**From:** Nowell, Keith, Env. Health  
**Sent:** Friday, October 02, 2015 2:54 PM  
**To:** 'Forrest Cook'  
**Cc:** Mona Hsieh; Roe, Dilan, Env. Health  
**Subject:** RE: Updated Site Map and Photos - 3101 35th Ave., Oakland, CA

3101 35th AVENUE  
OAKLAND, CALIFORNIA

DETAILED SITE MAP  
SHOWING PROPOSED BORING LOCATIONS

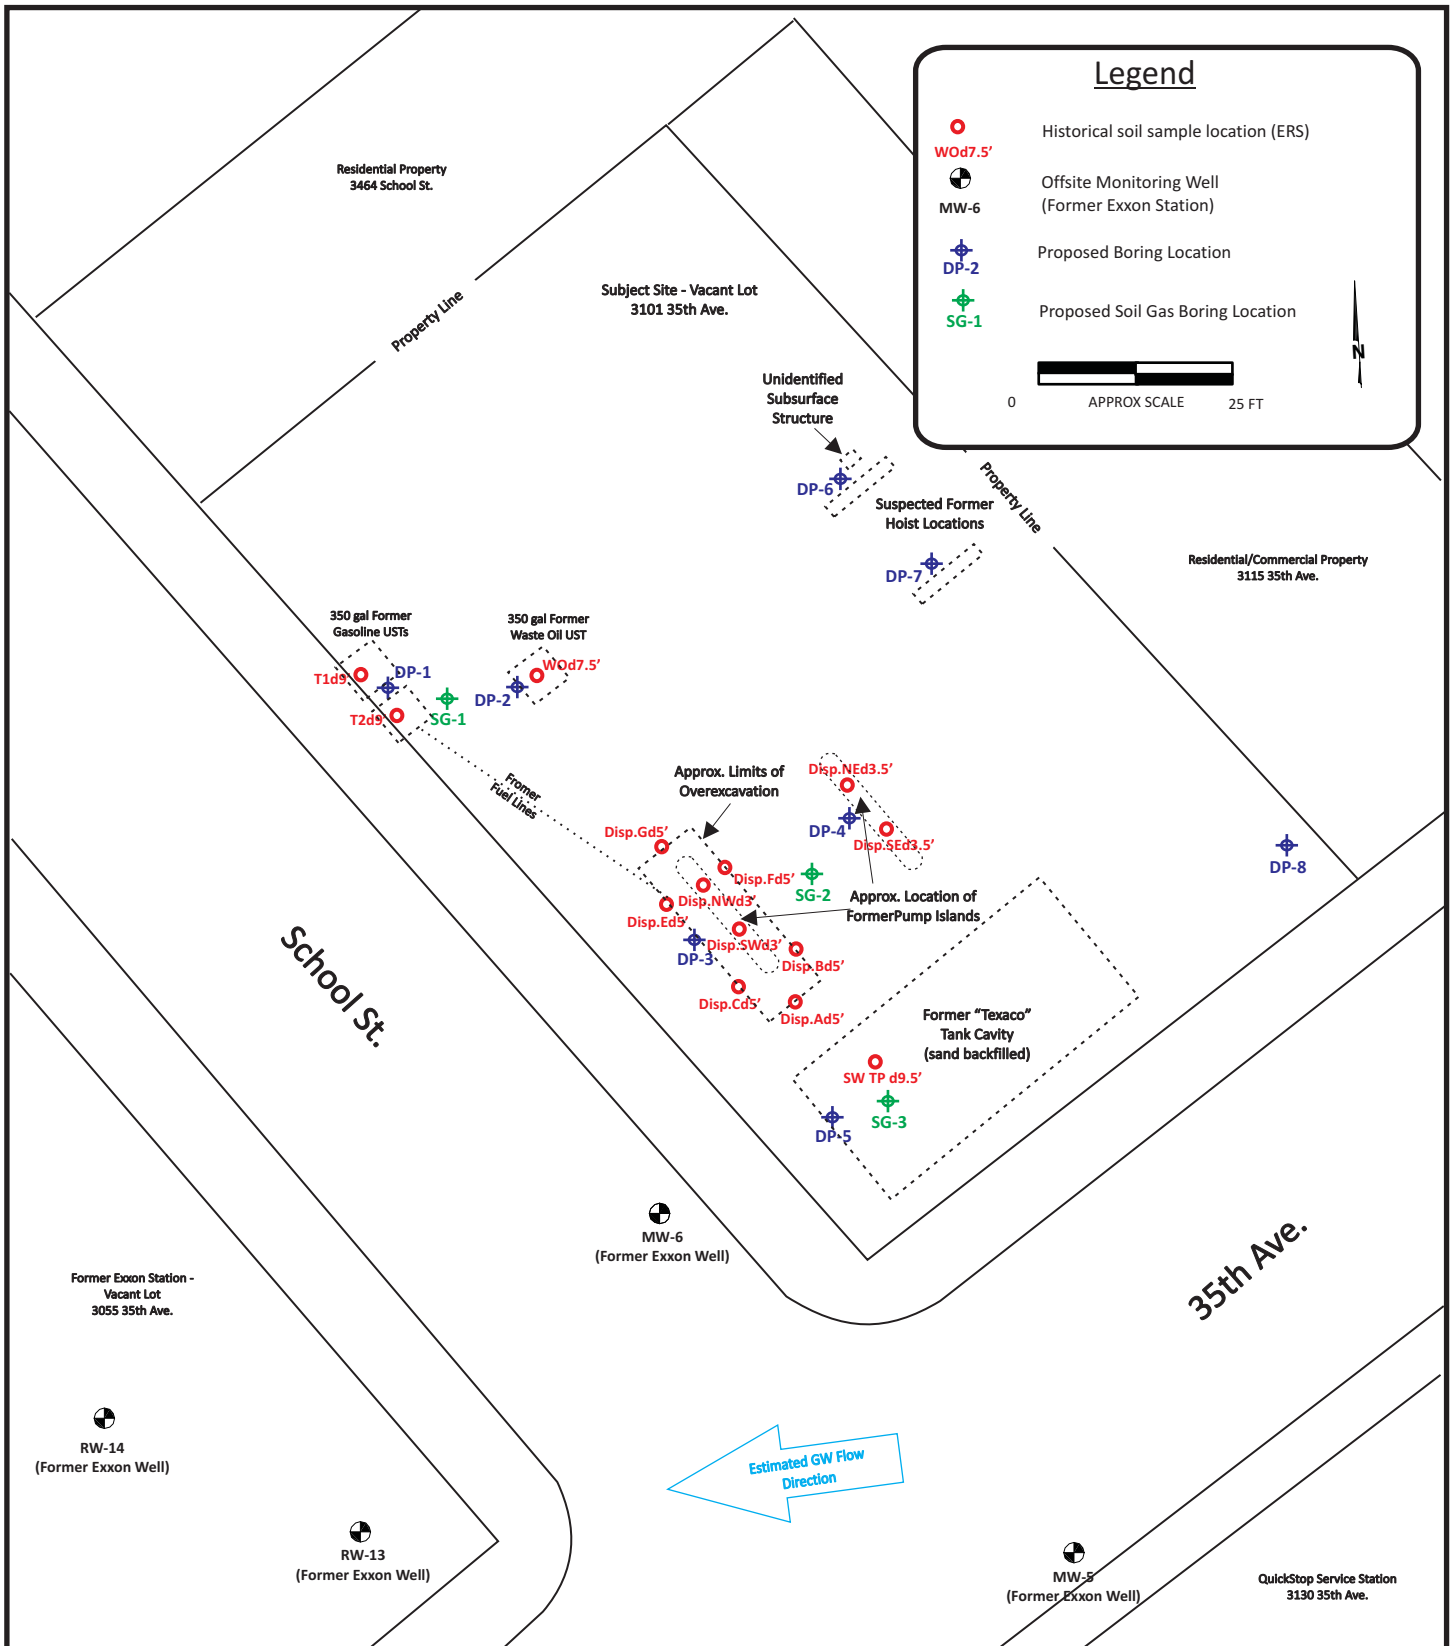
Good work. Your revised boring locations are acceptable to ACEH. Please proceed with the investigation.

I have no idea what the plate is covering. It may be a sump drain cover. Our resident service station expert is out of the office today. I'll try to get his feedback. Please pop the cover on you next site visit for a look-see and get back to me. Due to its location adjacent to one of the potential hoists, boring location DP-6 should also evaluate the any impacts associated with the covered structure.

We were finally able to clear of the area of this site where a suspected hoist was formerly identified as part of a Phase I. I found two patches of concrete which, almost with out a doubt, were former hoists. Additionally, adjacent to one of the hoists was a strange metal lid of some sort set into the concrete (see the attached pictures). I honestly, have never encountered something like this before. Any ideas what it might be?

Regardless, at your request, we will do three additional borings in the locations shown on the new revised map (attached Figure 5).
